FINAL ENVIRONMENTAL IMPACT REPORT

COCHRANE ROAD PLANNED UNIT DEVELOPMENT

SCH# 2004112060

OCTOBER 2005

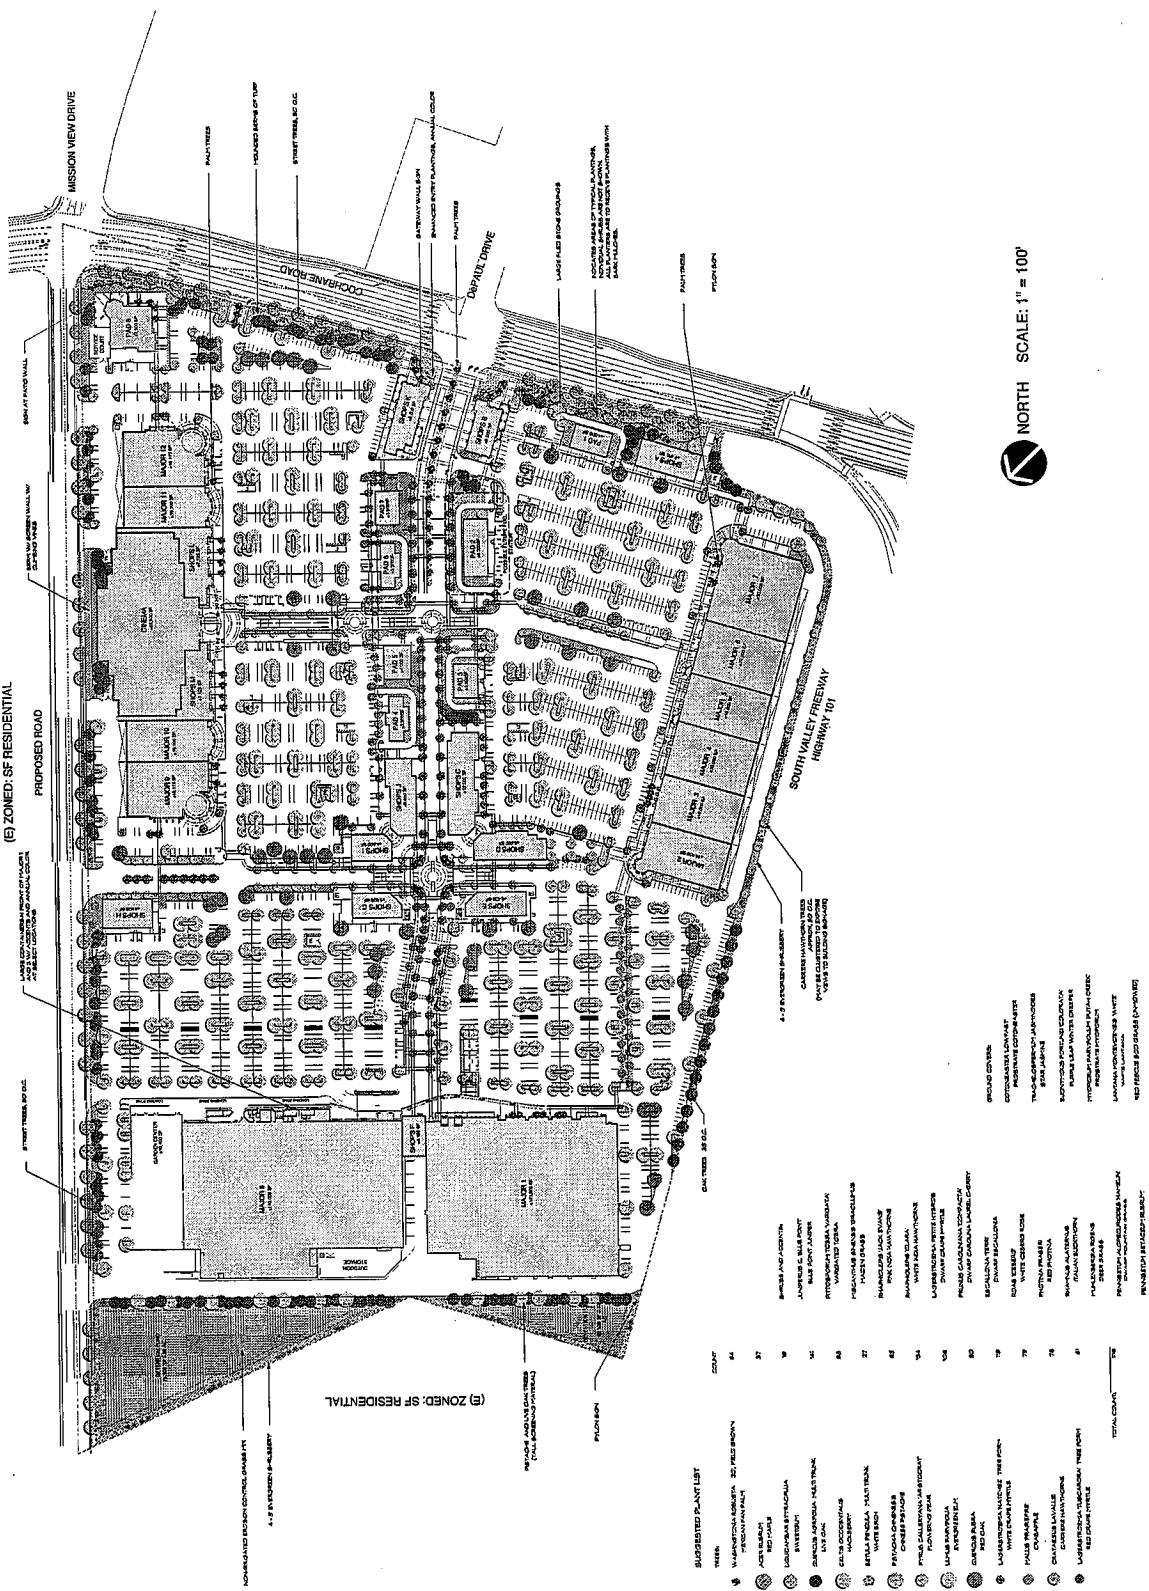
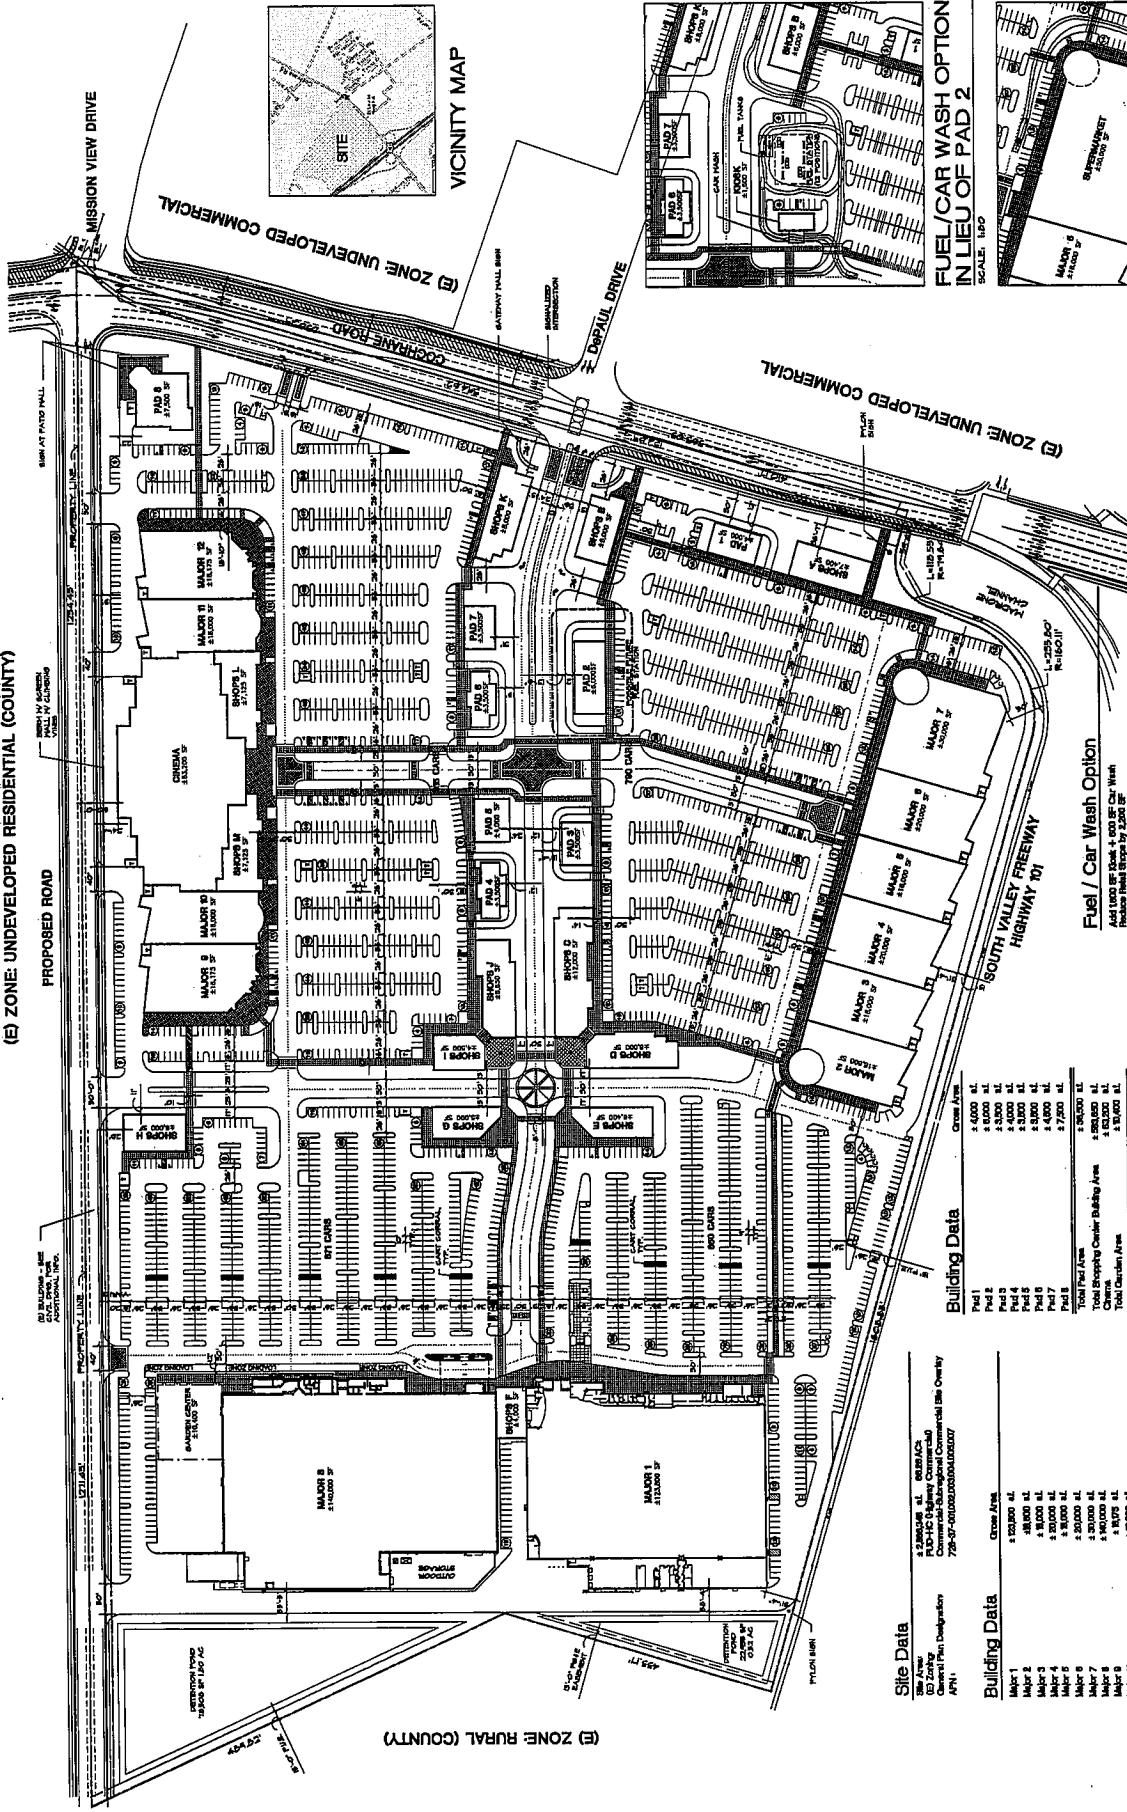
- 3-4** 4. I was deeply disappointed by the Site Plan [Figure 2-8] and the Conceptual Elevations [Figure 2-9]. The overall impression is of a park for automobiles. The architectural style is derivative and does not reflect the new spirit of Morgan Hill as an aspiring, progressive community. Morgan Hill deserves better. When I visited in July, I was pleasantly surprised by the imaginative plan and look of the Industrial Park and by the quality of the recently built homes and those under construction on both sides of Cochrane. Surely the Shopping Center could be more innovative.

V. The proposed lane configurations described in various locations in the DEIR don't match up with what is shown in Figure 2-8 and Figure 2-10 at both new proposed intersections. It described 1 through lane in the EB direction at Cochrane and De Paul but the figures show 3 through lanes. It also described 1 shared left-turn/through lane and 1 right-turn lane at Mission View and Cochrane but the figures show 3 through lanes, a left-only, and a right-only. This makes it difficult to comment on the lane configurations of the proposed intersections.

7-10 My various comments regarding lane configurations at the two new signalized intersections should be minimum, there should be more additional through lanes in all directions at both intersections, similar to what is shown on Figure 2-8 and Figure 2-10.

Comment noted. The lane configuration was not clearly designated on the site plan in Figure 2-8 of the Draft EIR, however the site plan shown in the traffic impact analysis (dated June 2005) assumed the lane geometry for the Cochrane Road/De Paul Drive intersection is assumed as follows:

A revised conceptual landscaping plan (Figure 2-10) that was defined after release of the Draft EIR and a revised site plan (Figure 2-8) that shows the correct lane configuration noted within the Draft EIR is incorporated herein.
